# Access Compliance Report

## Public Rights-of-Way

Intersection ID: 10023486	Main Street: CIRCUMFERENTIAL_RD	Cross Street: N/A	Location: NW
ADA ID: 5D29D5D5306D	Ramp Type: Directional1	Initial Pass/Fail: Fail	Overall Compliance: No
		Severity Score: 10

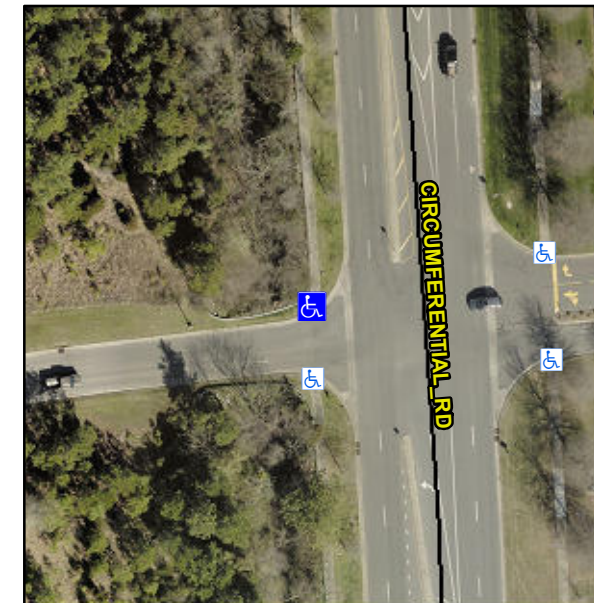
**R304.5.1, R304.5.3**

Compliance	Description	Data	Compliance	Description	Data
N/A	Ramp Length (in)	66.0	N/A	Grade Break?	N/A
No	Ramp Width (in)	44.5	N/A	Grade Break Slope (%)	0.0
Yes	Ramp Slope (%)	1.5	N/A	Grade Break XSlope (%)	0.0
No	Ramp XSlope (%)	5.0			
N/A	Flare Type LT	N/A	N/A	Flare Type RT	N/A
N/A	Flare Slope LT (%)	N/A	N/A	Flare Slope RT (%)	0.0
N/A	Flare Traversable LT?	N/A	N/A	Flare Traversable RT?	N/A
N/A	Landing Length (in)	0.0	N/A	DWS Provided?	N/A
N/A	Landing Width (in)	0.0	N/A	DWS Contrast?	N/A
N/A	Landing Slope (%)	0.0	N/A	DWS Length (in)	N/A
N/A	Landing X Slope (%)	0.0	N/A	DWS Full Width?	N/A
N/A	Landing Curb? (Y/N)	N/A	N/A	DWS Offset LT (in)	N/A
N/A	Shared Landing?	N/A	N/A	DWS Offset RT (in)	N/A
N/A	Gutter Ponding?	0.0	N/A	Gutter Slope (%)	N/A
N/A	Gutter Lip Ht (in)	0.0	N/A	Gutter X Slope (%)	N/A
N/A	Painted X Walk1?	No		Road Slope (%)	1.3
	X Walk 1 Direction	To S		Road X Slope (%)	0.7
	X Walk 1 Width (in)	N/A		Clear Space?	N/A

**Remove & Replace Entire Ramp.**
